# West Oakland Link Initial Study/ Mitigated Negative Declaration Addendum

**NOVEMBER 2024**

### 1.3 Proposed Revised Project

T5c SOUTH BURMA ROAD RAMP

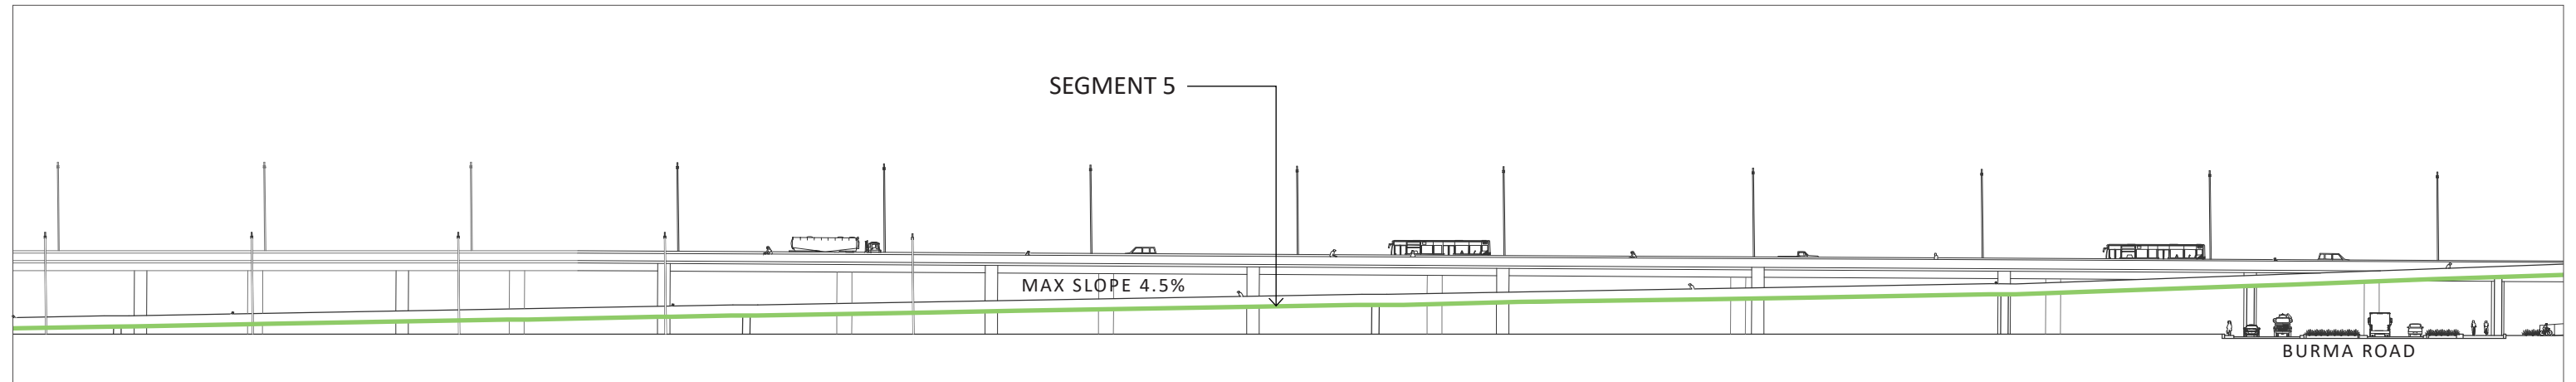
Segment 5 of the Proposed Revised Project, as shown in Figures 1-8a, 1-8b, and 1-8c, would have a slightly different configuration and continue for 200 feet at grade before connecting to the Bay Bridge Trail north of the I-80/I-880 connector. Segment 5 would include a seating area that would be located at grade, providing a bench and shade. This would be set back from the path but within overall pathway area. In addition, Segment 5 would include other ramps to access the Bay Bridge Trail that were not discussed in the Adopted IS/MND:
